**Minutes of the Parks & Recreation Committee Meeting  
Bronx Community Board 8  
Wednesday, October 22, 2025 at 7:00pm  
Board Office – 5676 Riverdale Ave, Suite 100, Bronx, NY 10471**

**4. Fort Independence Playground & Public Restroom Building Design**

Ft. Independence Playground Site Revision Plan Attached

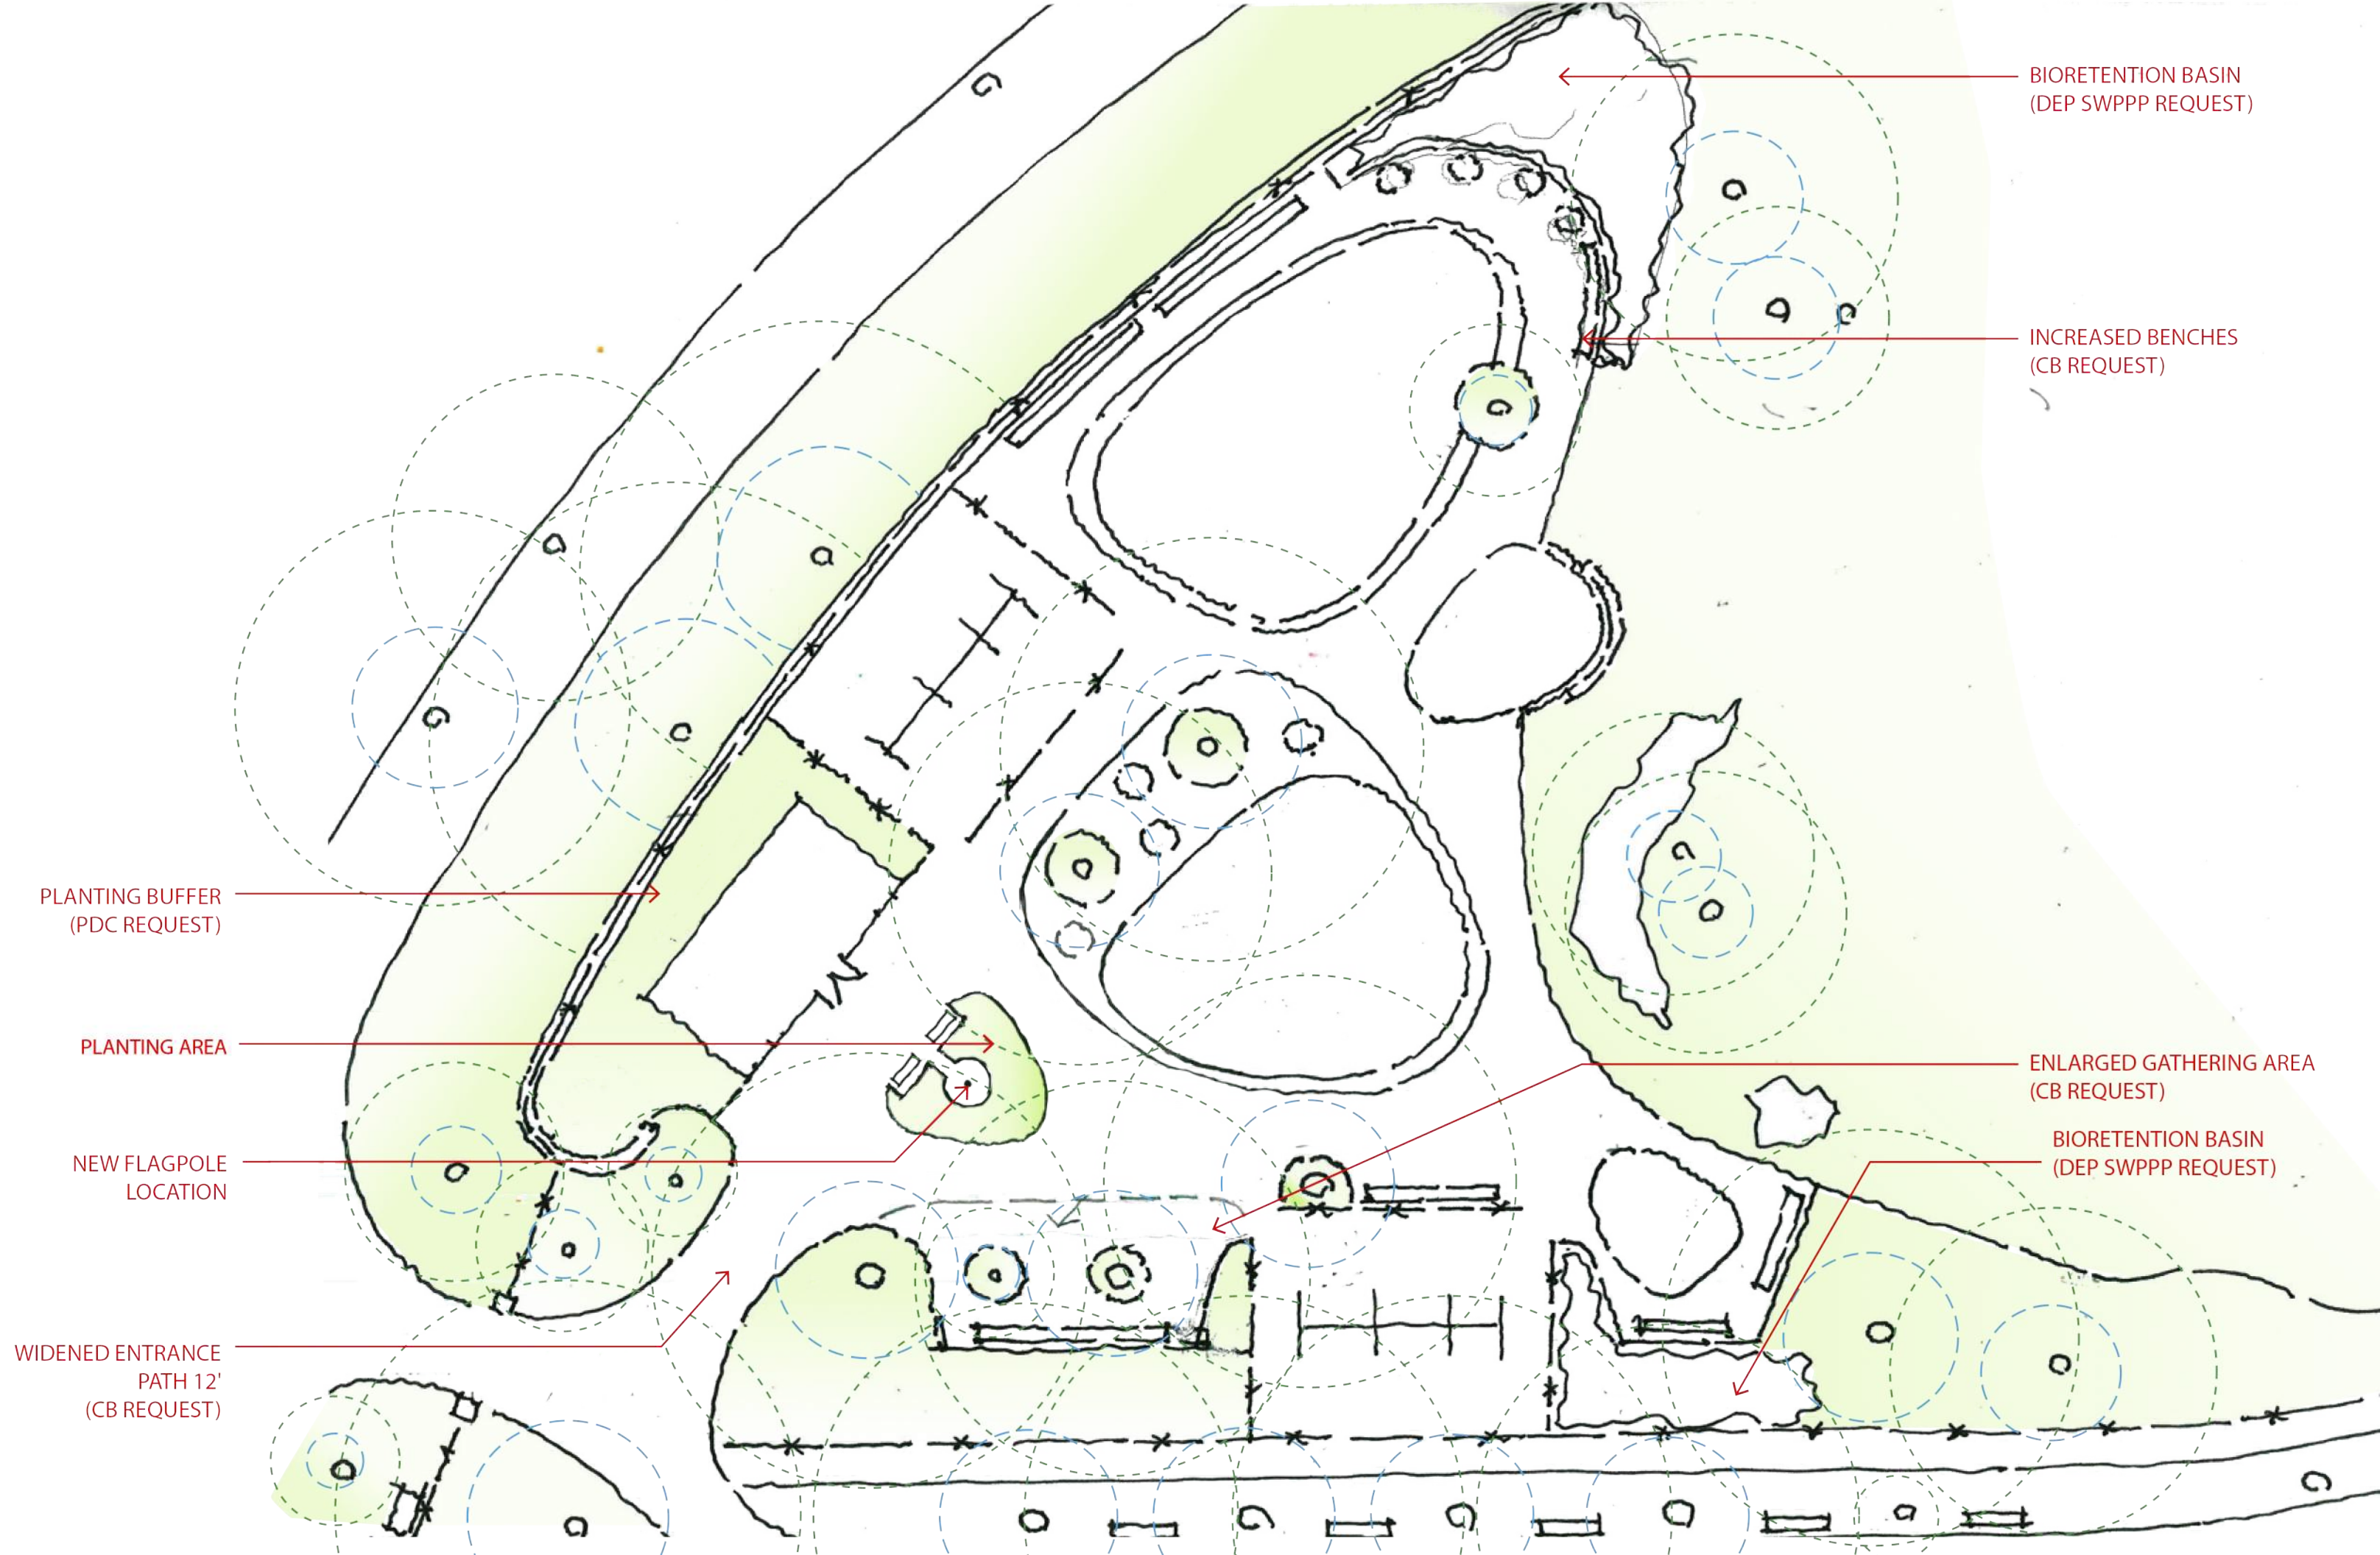
The Parks Department presented their revised plan for Fort Independence Playground. In response to feedback from the community, the changes included:

- Widening the walkway into the playground from ten feet to twelve feet
- Adding an area for children's birthday parties
- Adding removable bollards to prevent vehicle use on the walkway
- Moving the restroom structure closer to the flag pole area and moving the flag pole into the play area
- Adding benches
- Adjusting the planting list to native plants

- Keep the Giles Street entrance open - Parks will do their best to keep a four-foot-wide access path into the park available during construction. There may be brief periods when this is not possible due to the proximity of the pathway to the construction site
- Adding additional baby bucket seats for a total of four

The Parks Department is unable to accommodate a request by the community to move the restroom further into the park so that it is not visible from the street. As an accommodation, the Parks Department is adding plantings around the restroom to soften the border.

- The elimination of the proposed green area around the flag pole to allow the children to interact with the pole. Parks agreed.
- More shade trees planted on the hill – Parks Dept will consider this, but this is dependent on the results from boring tests during the design phase
- The integration of pigeon themes into the playground since the park is locally known as Pigeon Park. Parks suggested adding pigeons to the panels on the play equipment.

INCREASED BENCHES  
(CB REQUEST)

ENLARGED GATHERING AREA  
(CB REQUEST)

PLANTING BUFFER  
(PDC REQUEST)

NEW FLAGPOLE  
LOCATION

WIDENED ENTRANCE  
PATH 12'  
(CB REQUEST)
